Notes for the kick off meeting on stage1

Stage 1 Structure

Item # 42– Tooling posts –

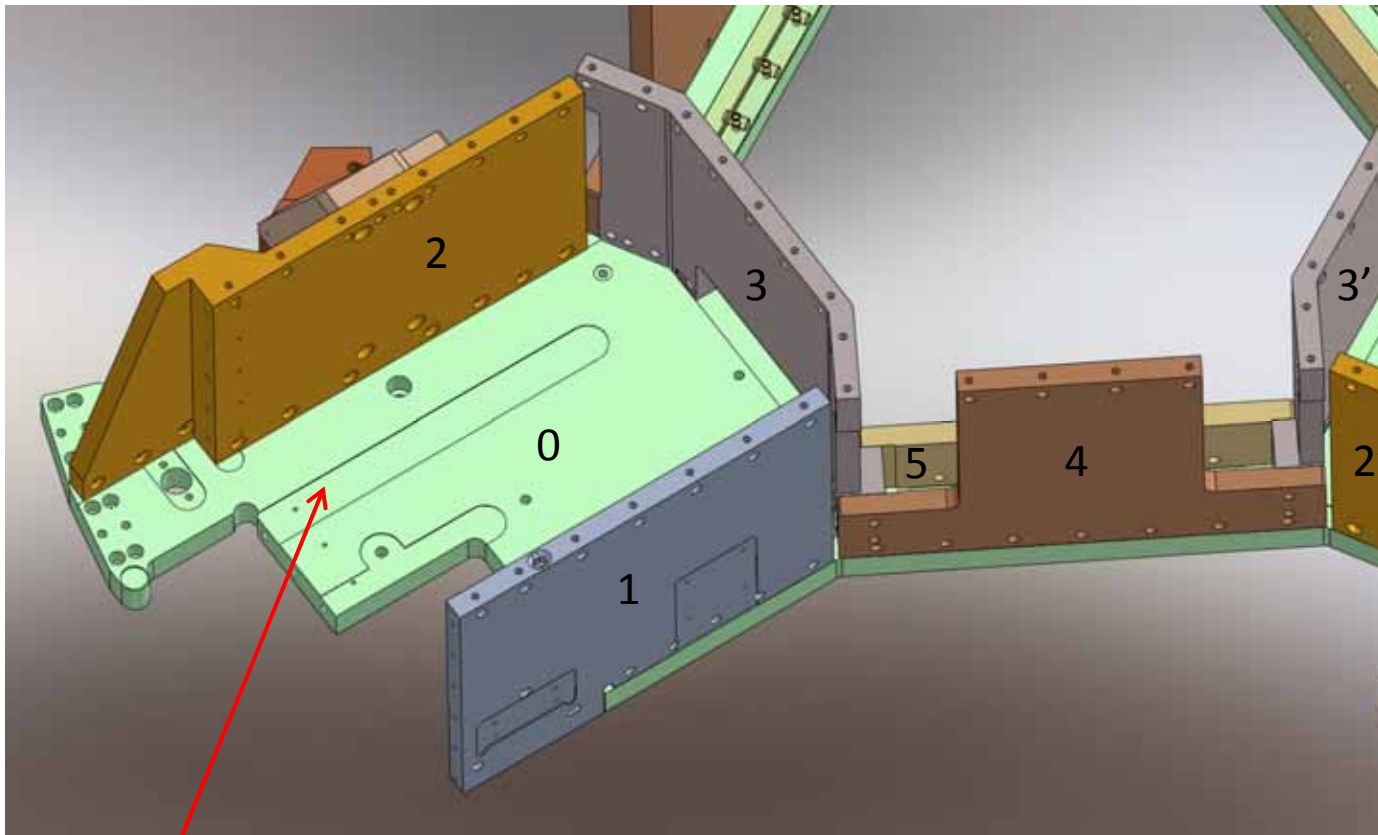
Stage 0-2 Tooling Post

Stage 1-2 Tooling Post

2- Parts referencing: moving to plates pinning

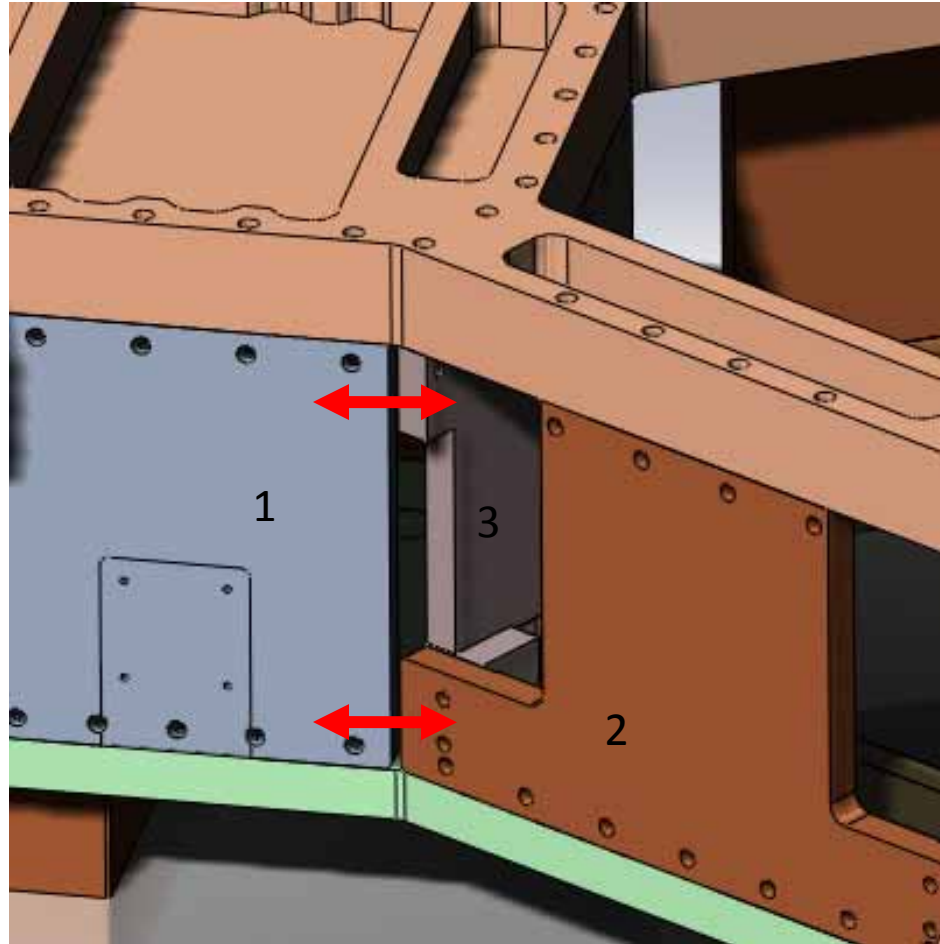
Decision regarding cut off

FEA results

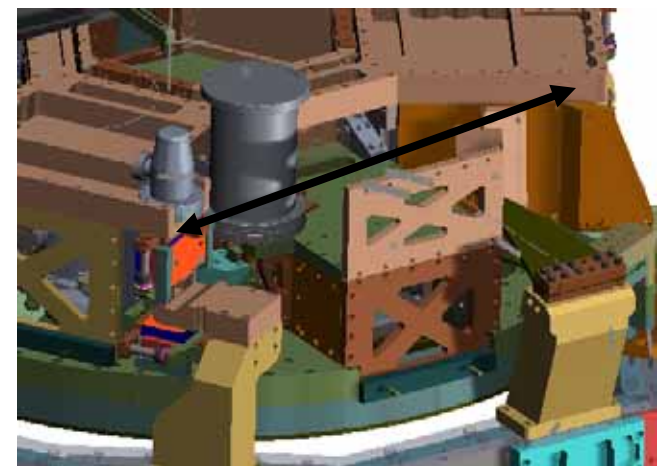
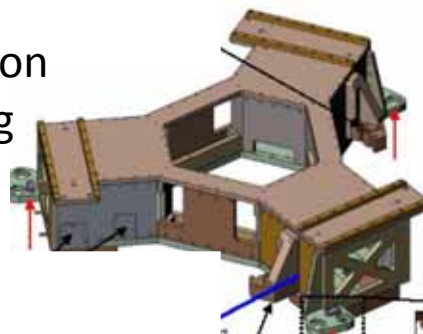
3- Improve the connection between plates

5- Trim masses

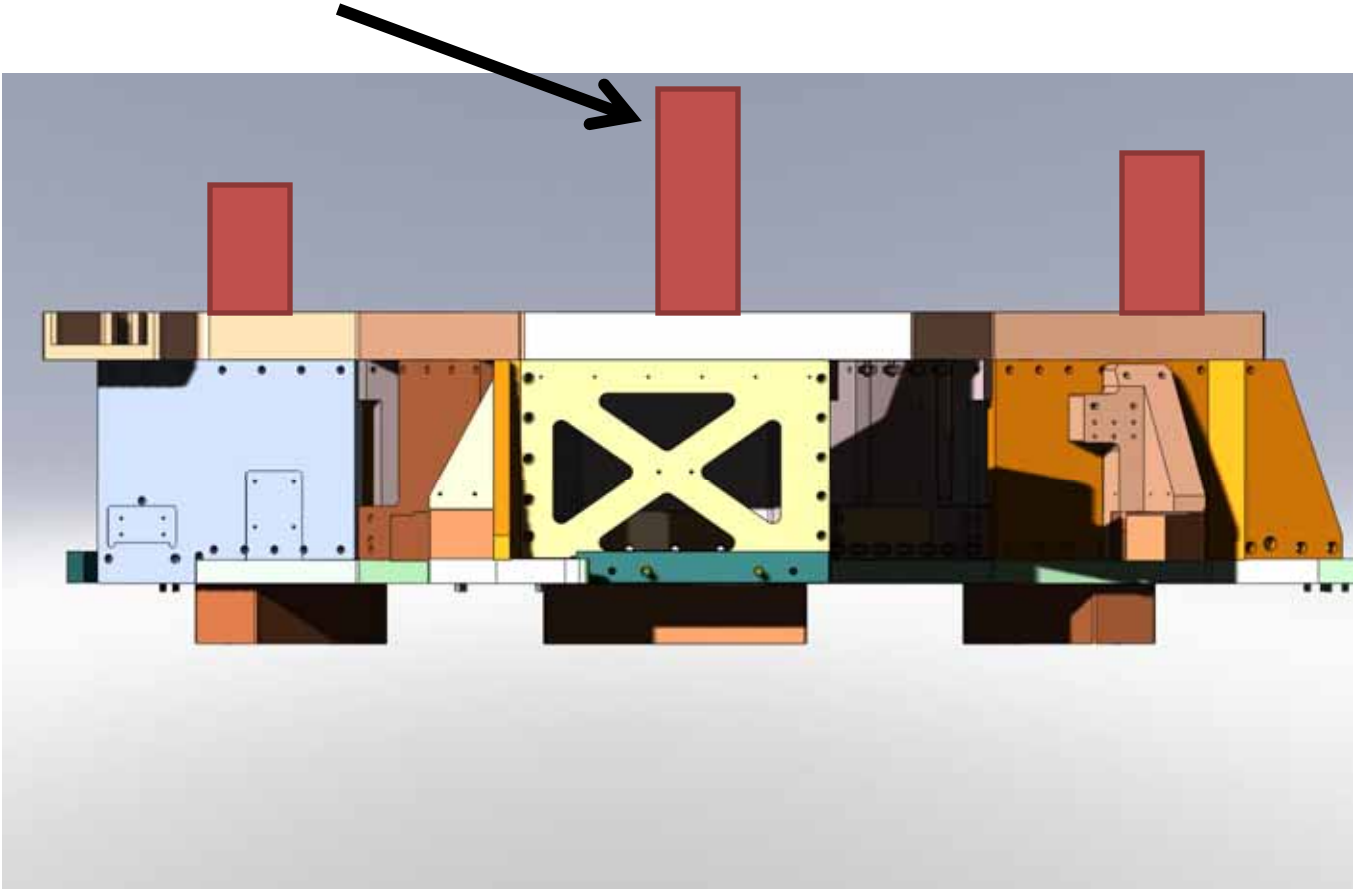
No more stacks
